Access Compliance Report Public Rights-of-Way (Curb Ramps)

Intersection ID: 12548 Main Street: E_MARTIN_LUTHER_KING_JR_CBVss Street: S_TRYON_ST Location: S

ADA ID: 08BDC07BE3FD Ramp Type: PerpDiag Initial Pass/Fail: Fail Overall Compliance: No Severity Score: 33.75

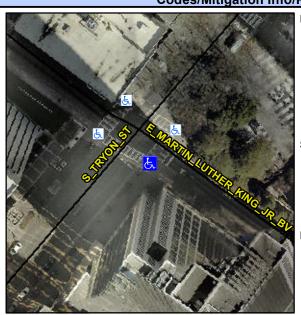
Remove & Replace Curb Ramp With Two New Directional Ramps or Equivalent.

R304.5.1, R304.2.2, R304.5.3

| Compliance Description | | Data | Compliance Description | | Data |
|------------------------|-----------------------|-------|------------------------|-----------------------------|-------|
| N/A | Ramp Length (in) | 77.0 | No | Ramp Slope (%) | 9.1 |
| No | Ramp Width (in) | 40.0 | No | Ramp XSlope (%) | 5.9 |
